SUBJECT: COMANCHE PEAK STEAM ELECTRIC STATION, UNITS 1 AND 2 -
ISSUANCE OF AMENDMENTS RE: INCREASE IN ALLOWABLE SPENT FUEL
STORAGE CAPACITY AND CREDIT FOR SOLUBLE BORON IN THE SPENT
FUEL POOL (TAC NOS. MA4841 AND MA4842)

AMENDMENT TO FACILITY OPERATING LICENSE

ATTACHMENT TO LICENSE AMENDMENT NO. 74

SAFETY EVALUATION BY THE OFFICE OF NUCLEAR REACTOR REGULATION

FIGURE 3.7.17-1
Fuel Assembly Burnup vs. U-235 Enrichments vs. Decay Time Limits for
All Cell Storage in High Density Spent Fuel Storage Racks

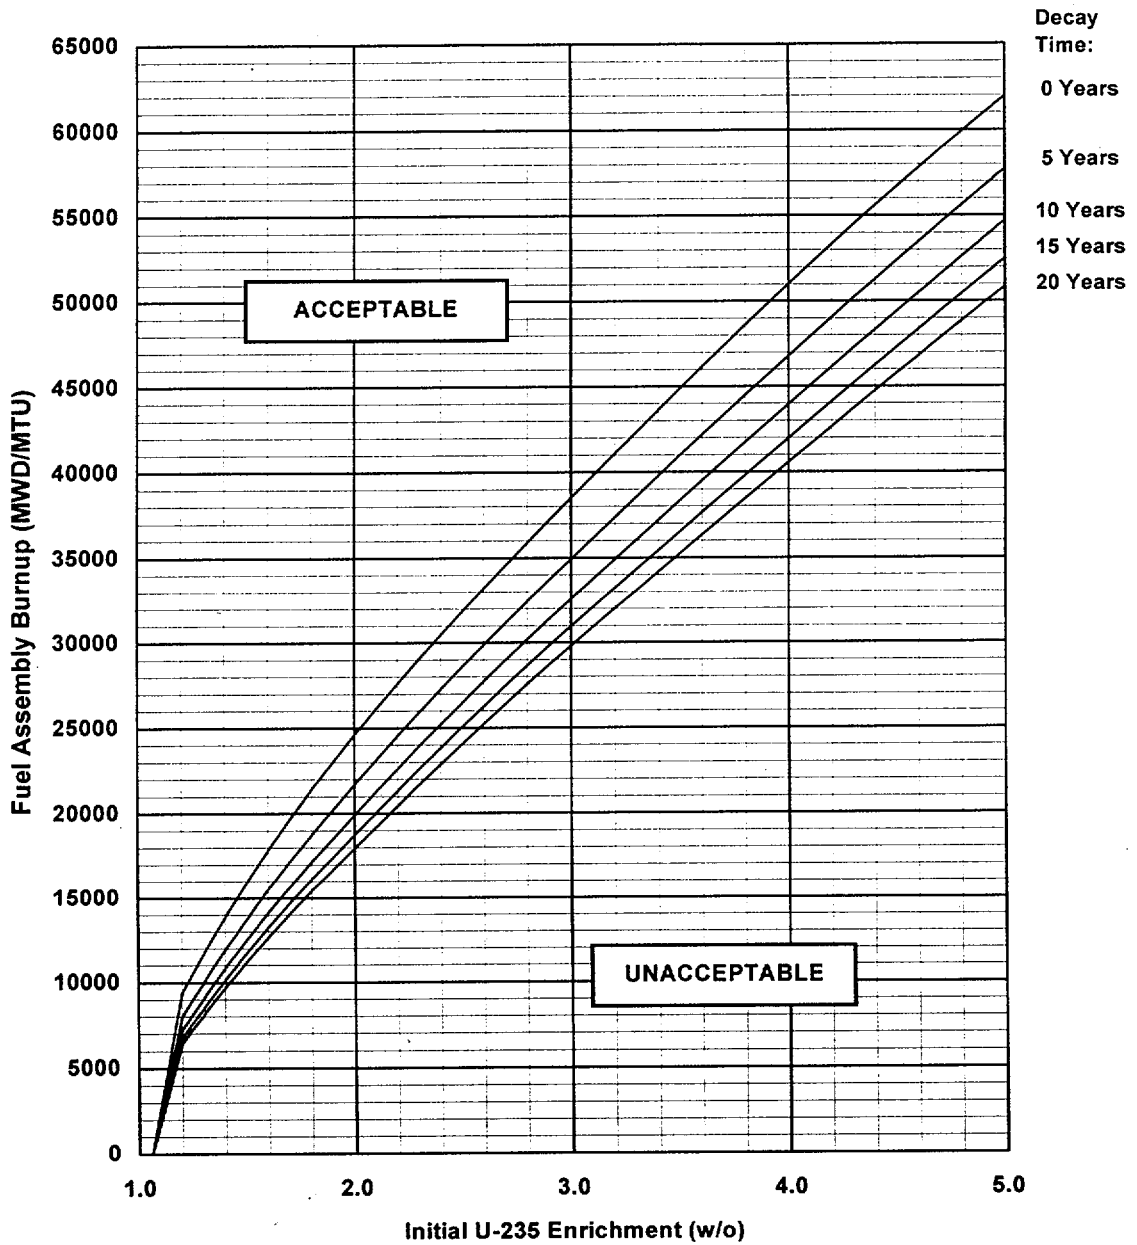
Assemblies with initial nominal enrichments no greater than 1.06 w/o U-235 can be stored in any cell location. Fuel assemblies with initial nominal enrichments greater than 1.06 and up to 5.00 w/o U-235 must satisfy the minimum burnup requirements shown in proposed TS Figure 3.7.17-1.

- The licensee has proposed a revision to CPSES TS 3/4.7.17, "Spent Fuel Assembly Storage." The proposed changes would incorporate limitations for "All Cell Storage" and "3 out of 4 Storage" configurations in TS Figures 3.7.17-1 and 3.7.17-2, respectively. These TS figures are acceptable as described in Section 3.5, herein. A revised TS Figure 3.7.17-1, for the "2 out of 4 Storage Configuration" would become TS Figure 3.7.17-3. The existing TS Figure 3.7.17-1 was found to contain a minor error which resulted in an overly restrictive requirement for storing fuel in a "2 out of 4 Storage Configuration." The NRC staff concludes that the revised TS Figure 3.7.17-1, which becomes TS Figure 3.7.17-3, is acceptable. A new TS Figure 3.7.17-4 would be added to provide a pictorial definition of the various acceptable fuel storage configurations. These pictorial definitions are consistent with the NRC staff's understanding of the definitions of the various acceptable storage arrays. Accordingly, proposed TS Figure 3.7.17-4 is acceptable.

- g. New or partially spent fuel assemblies with a discharge burnup in the "acceptable" domain of Figure 3.7.17-1 may be allowed unrestricted (all cell) storage in high density fuel storage racks as shown in Figure 3.7.17-4.

Figure 3.7.17-2
Minimum Burnup vs. Initial U-235 Enrichment vs. Decay Time
For a 3 out of 4 Storage Configuration in High Density Racks

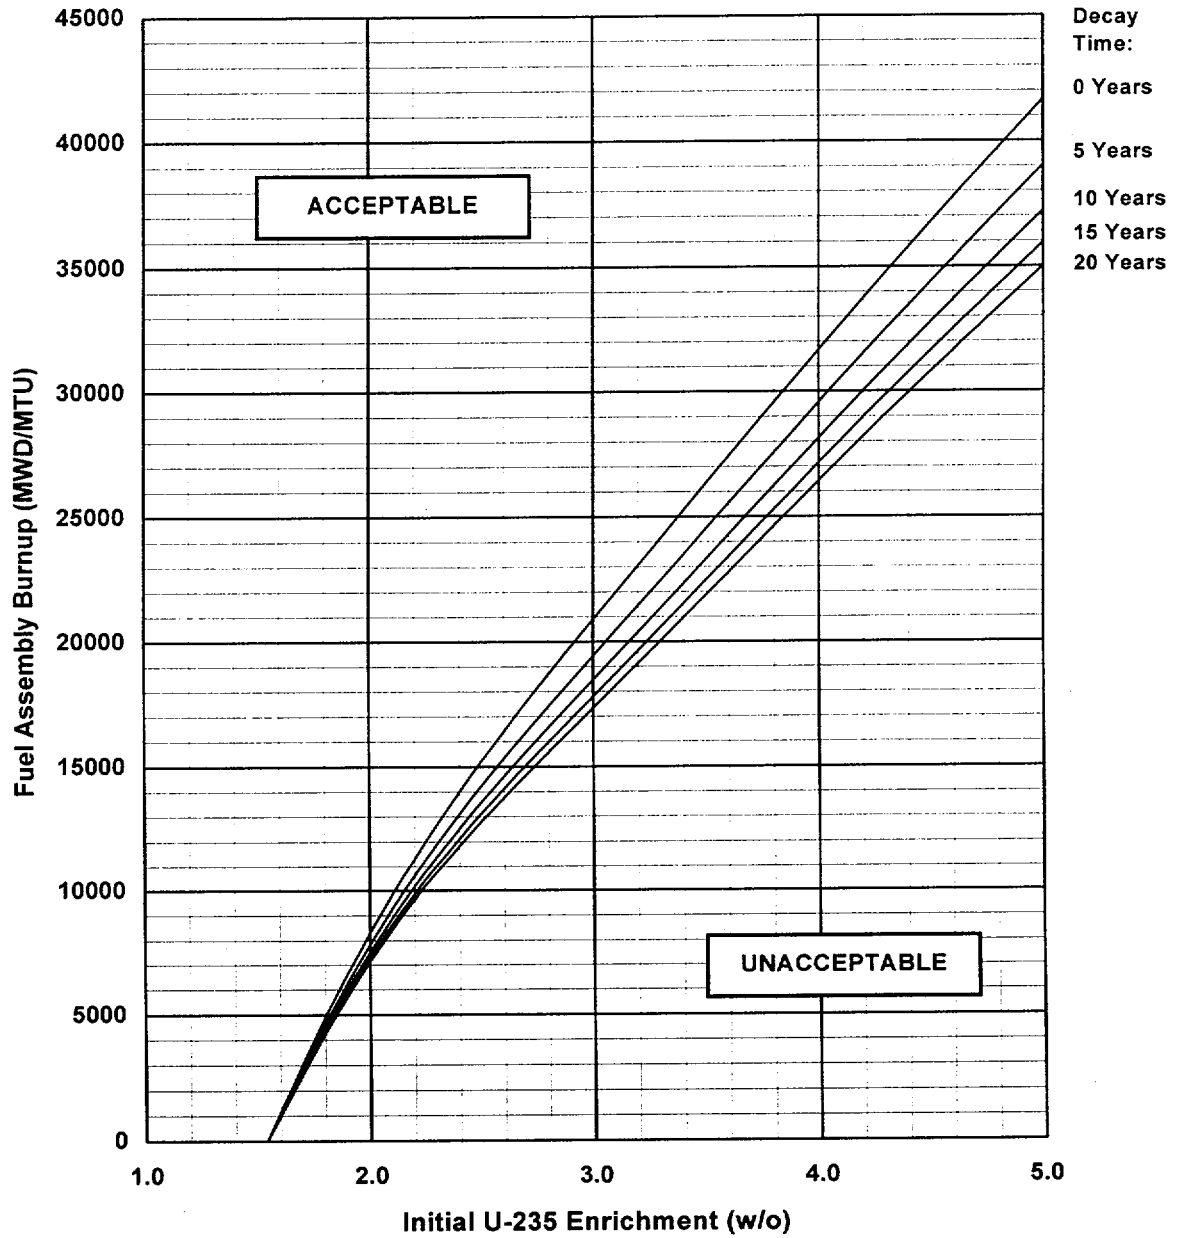
Assemblies with initial nominal enrichments no greater than 1.54 w/o U-235 can be stored in a 3-out-of-4 storage configuration arrangement with empty cells. Fuel assemblies with initial nominal enrichments greater than 1.54 and up to 5.00 w/o U-235 must satisfy the minimum burnup requirements shown in proposed TS Figure 3.7.17-2.

- h. New or partially spent fuel assemblies with a discharge burnup in the "acceptable" domain of Figure 3.7.17-2 may be allowed restricted storage in a 3 out of 4 configuration in high density fuel storage racks as shown in Figure 3.7.17-4.
